**HANOVER REED STREET**

**Application for a Consolidated Planned Unit Development and  
Related Zoning Map Amendment**

**PREHEARING SUBMISSION**

**April 8, 2022**

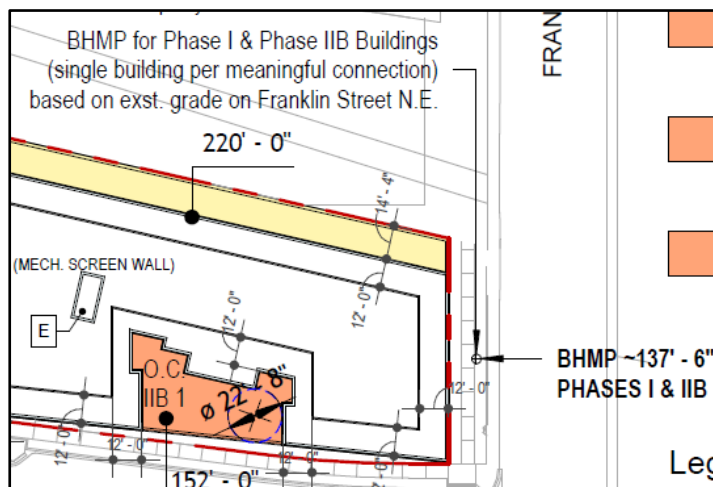
The Commission asked the Applicant to provide additional justification regarding the proposed rezoning of the western portion of the PUD Site to MU-6A, as well as the proposed density in the West Building, which is 5.23 FAR. The proposed MU-6 zone is the appropriate zone because it allows the necessary height, density, and mix of uses for this Project that has been closely coordinated with the community.

Although a PUD in the MU-7 zone would meet the height and density requirements for this project, the Applicant believes that the MU-6A zone is appropriate given the significant amount of MU-6 zoning in the surrounding area and that the height and density proposed fit within the existing context of the recent developments in the area that were developed as a matter of right under the existing MU-6 zone. The height and density of those projects relate well to the proposed construction. The Rowan building is located across Reed Street to the east and has an approximate height of 90 feet with a habitable penthouse above. The Brookland Press building is located immediately to the south of Phase I and has an approximate height of 85 feet.

In addition, the height and density of the overall Project has been closely negotiated with the community and has been designed to fit within the surrounding context, which has seen redevelopment in parts in recent years. The community requested that the tallest and most dense portions of the development be aligned with the tracks to the west. Thus, the design team has created a spine along the tracks that creates a new barrier between the tracks and the residential homes to the east. This massing then steps down as the building moves east, including incorporating functional and aesthetically pleasing open spaces for residents and integrating step backs to form a massing that creates an inviting streetscape that is compatible with the lower-scale residential uses to the east along Evarts Street. This articulation of the building has been further reduced the building's density throughout the design process. Furthermore, the Applicant removed a level from the Phase IIA Building in an effort to ensure that the overall project fits within the existing neighborhood.

Finally, the project will be built with non-Type I construction (i.e., stick construction). The Building Code limits the overall height of the project based on an average grade plane height calculation. The height that results from those limitations relates well to the Rowan building and the Brookland Press project, as noted above. Thus, the Applicant believes that the density as proposed addresses the competing priorities that inform the development of the PUD Site and is also "not inconsistent" with its designation for high density residential and PDR uses.
